II. REMARKS

Amendments to the Drawings:

The attached sheets of drawings includes changes to Figs. 1 and 13. These sheets replace the original sheets including Figs. 1 and 13.

FIG. 1

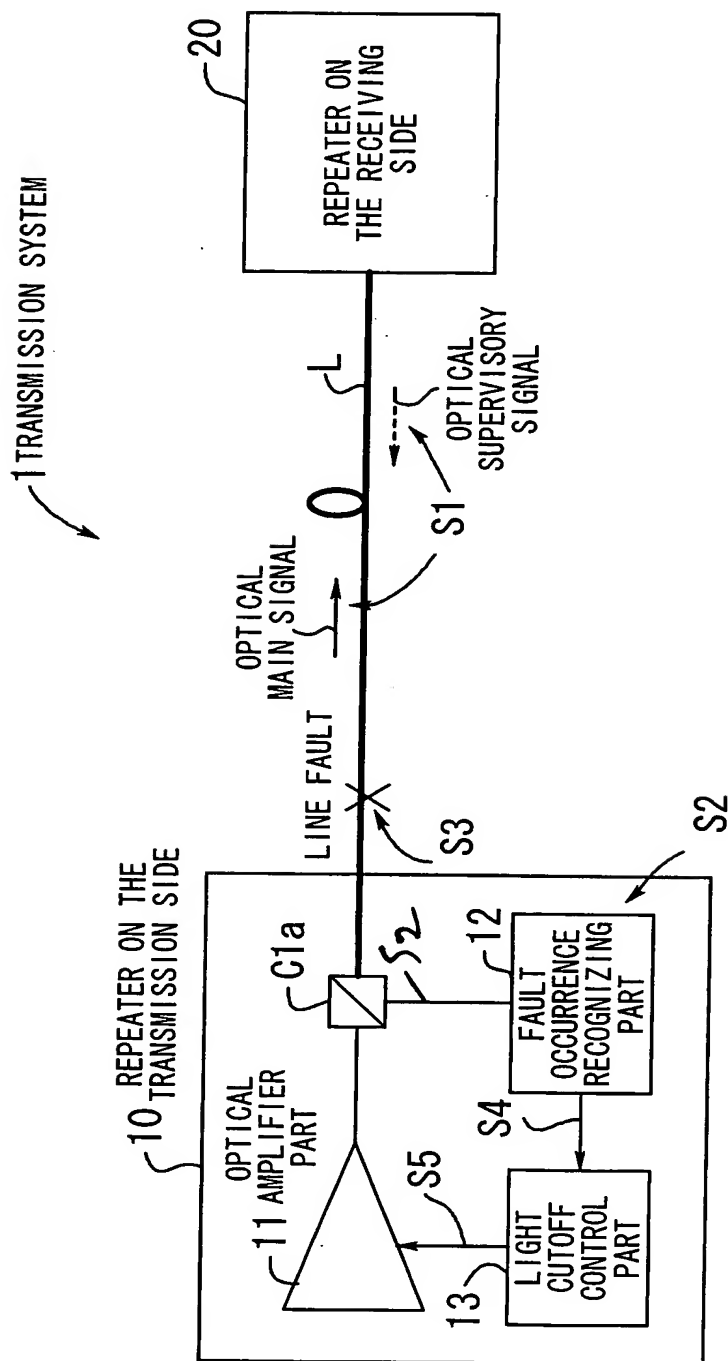
In Figure 1, step "S2" described in the written description is added. In Fig. 13, the step "S84" (upper occurrence) is corrected to --S83--, consistent with the written description.
